DART AEROSPACE LTD		Work Order: 45311
Description: Crosstube Assembly (205/212/412 Low Fwd)		Part Number: D212-664-147
Inspection Dwg: D212-664-147 Rev: B		Page 1 of 1

DART AEROSPACE LTD HAWKESBURY, ONTARIO, CANADA	
DRAWING NO. D212-664-147	REV. B SHEET 1 OF 4
TITLE CROSSTUBE (205/212/412 LOW FWD)	SCALE NTS
COPYRIGHT © 2007 BY DART AEROSPACE LTD THIS DOCUMENT IS PRIVATE AND CONFIDENTIAL AND IS SUPPLIED ON THE EXPRESS UNDERSTANDING THAT IT IS NOT TO BE USED FOR ANY PURPOSE OR COPIED OR COMMUNICATED TO ANY OTHER PERSON WITHOUT WRITTEN PERMISSION FROM DART AEROSPACE LTD.

DRAWING NO. D212-664-147	TITLE CROSSTUBE ASS'Y (205 LOW FWD)	REV. B	DART AEROSPACE LTD ENGINEERING ORDER		D.E.O. NO. D212-664-147-B-1	SHEET NO. SHEET 1 OF 1	SCALE NTS
DRAWN <i>q</i>	CHECKED <i>ASS</i>	MFG. APPR. <i>183</i>	APPROVED <i>inf</i>		DE APPR. <i>inf</i>		
DATE 11.07.15	DATE 11.07.20	DATE 11.07.21	DATE 11/07/21		DATE 11.07.21

REPLACE MAGNOBOND WITH PROSEAL.

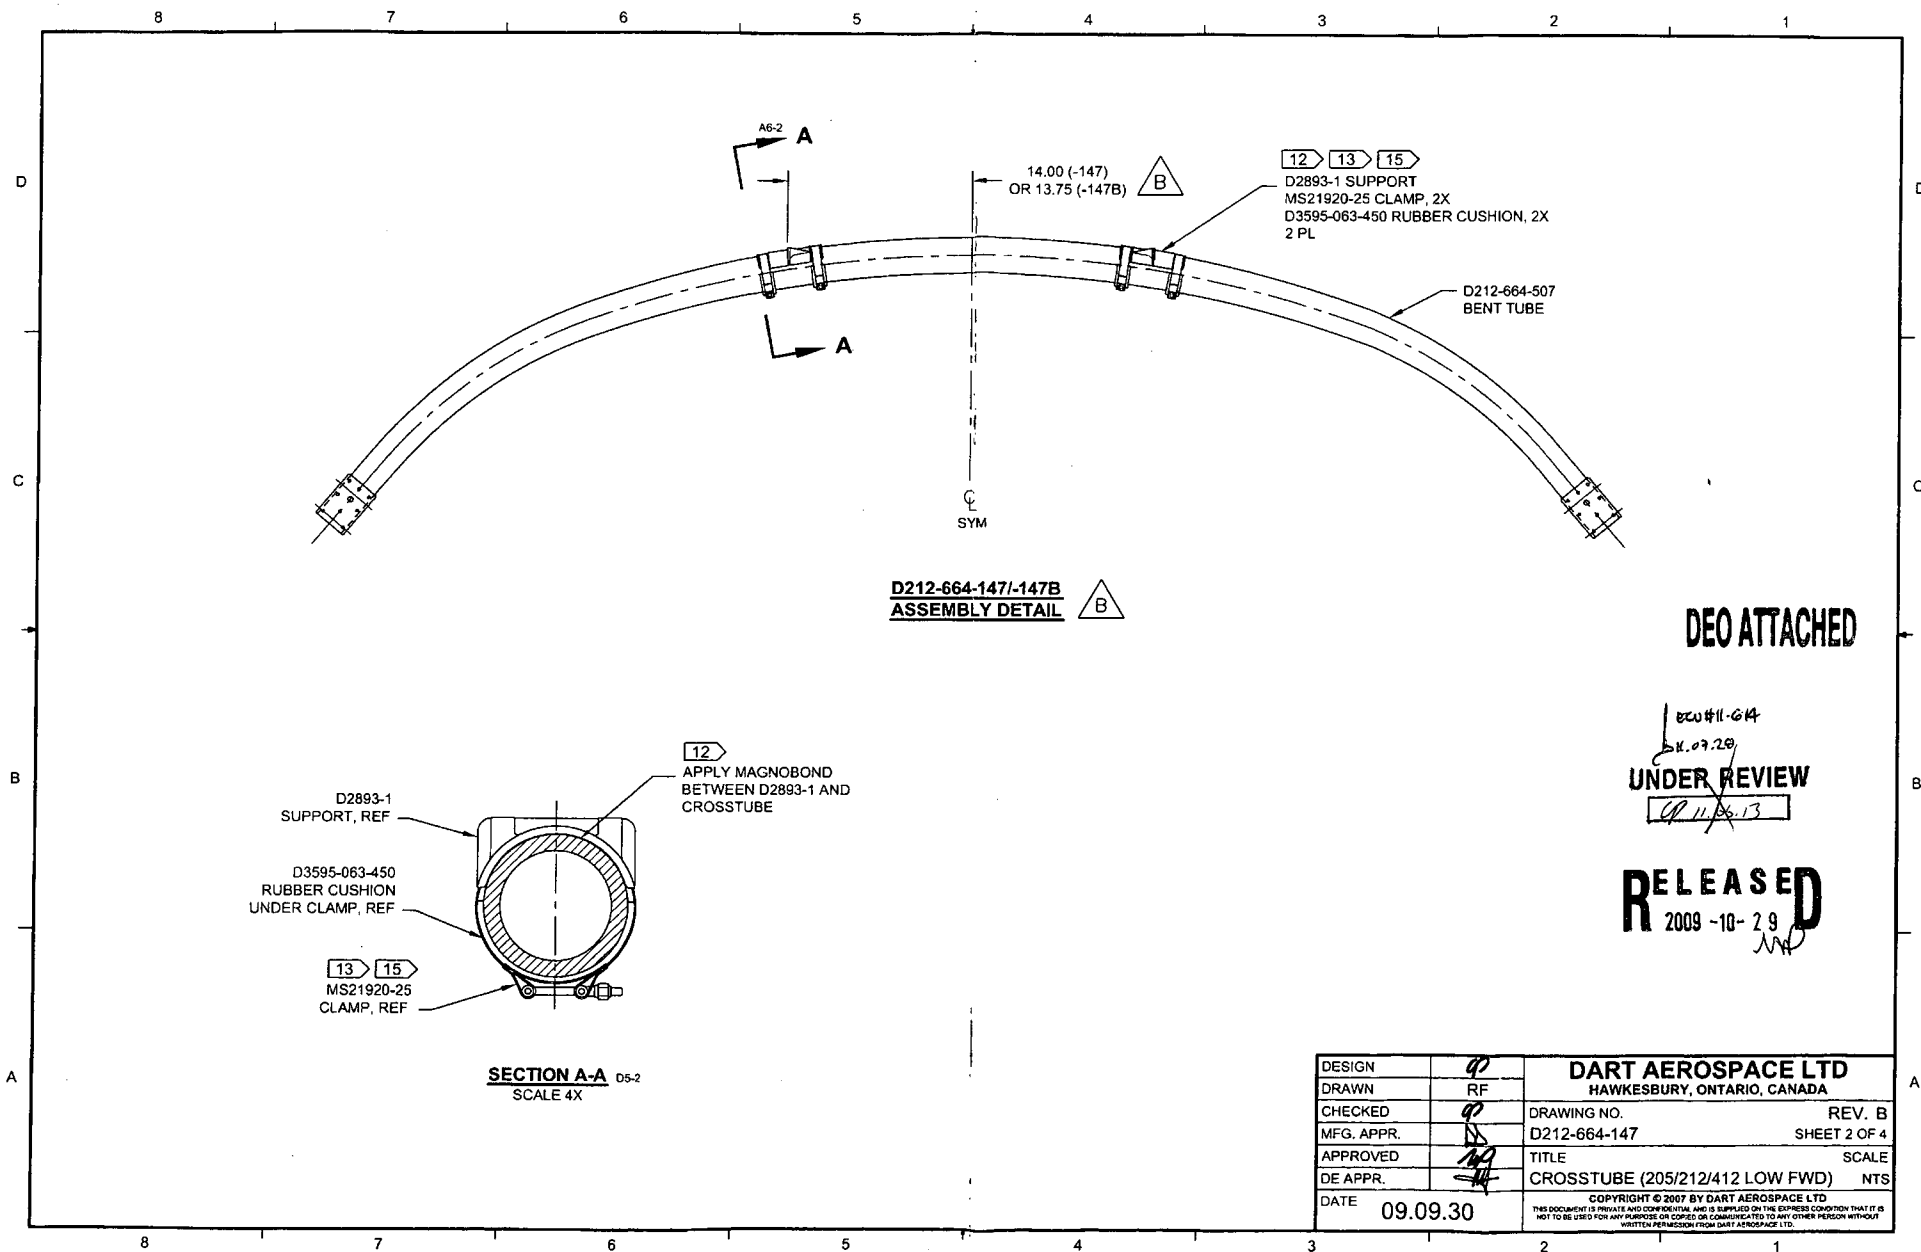
Per ECN#1164
110720
UNDER REVIEW

NOTE 12 & 15, SHEET 1 IS AMENDED AS FOLLOWS:

- 12) TO INSTALL D2893-1 SUPPORT: ABRASE MATING SURFACE OF SUPPORT AND CROSSTUBE WITH 180-GRIT SANDPAPER AND REMOVE RESIDUE WITH MEK (OR EQUIVALENT). APPLY A 0.04" TO 0.07" THICK LAYER OF PROSEAL 890 CLASS B-2 (OR AMS-S-8802 CLASS B-2) SEALANT TO MATING SURFACE OF SUPPORT.
- 15) TORQUE CLAMPS 80 TO 100 IN-LB. ENSURE AT LEAST 1.5 THREADS SHOWING IN SAFETY AND THAT NUT HAS NOT BOTTOMED-OUT AFTER TORQUING. **PRIOR TO PACKAGING, RE-CHECK TORQUE ON CLAMPS AFTER PROSEAL 890 SEALANT HAS CURED FOR 72 HOURS.**
